## Product Change Notification / SYST-05XJMF681

ERRATA - PIC18(L)F26/45/46K40 Family Silicon Errata and Data Sheet Clarification

## PIC18(L)F26/45/46K40 Family Silicon Errata and Data Sheet Clarification

**Figure 1. 28-pin SPDIP, SSOP, SOIC**

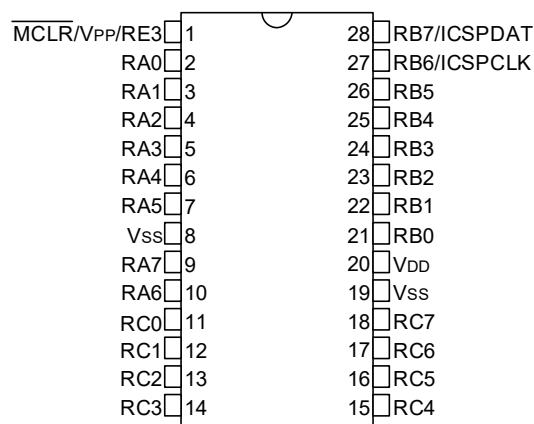
The correct marking for pin 26 on the 28-pin SPDIP/SSOP/SOIC package is **RB5**.

**Figure 3. 40-pin PDIP**

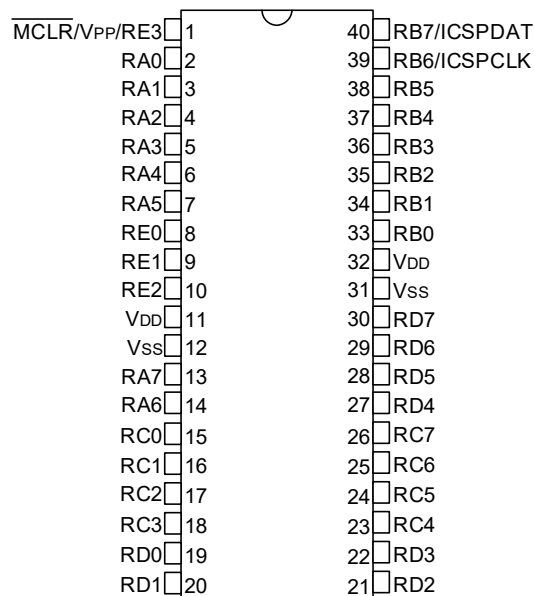
The correct marking for pin 38 on the 40-pin SPDIP package is **RB5**.

**Figure 38-10: ADC Conversion Timing (ADC Clock  $F_{OSC}$ -Based)**

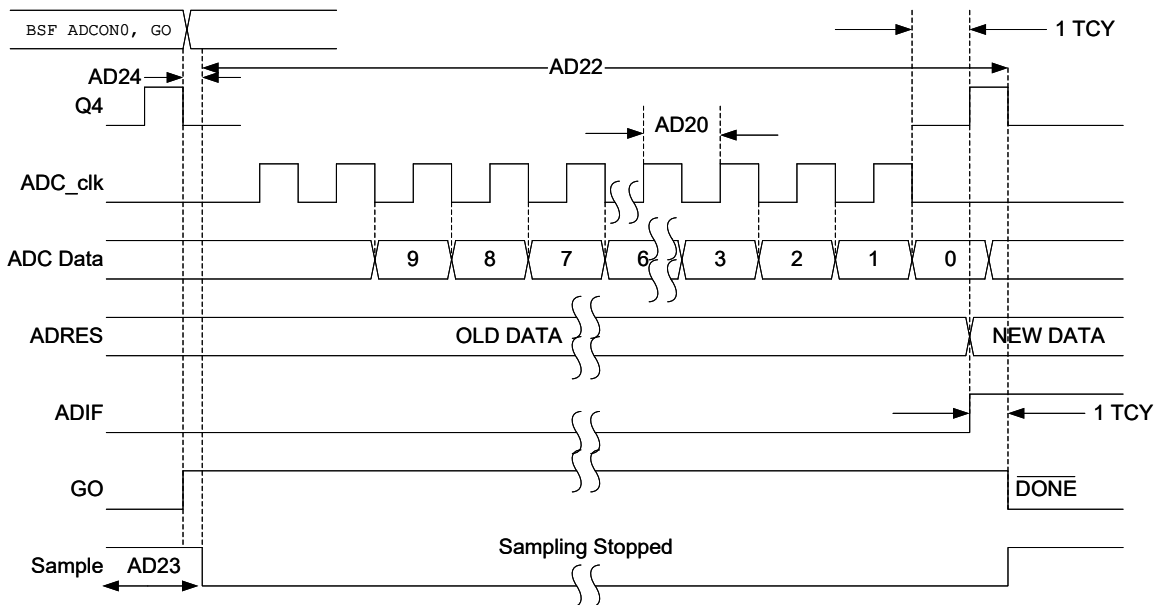
Refer to the images below for corrections of Figure 38-10 and Figure 38-11. Previously, the parameter numbers were incorrect.
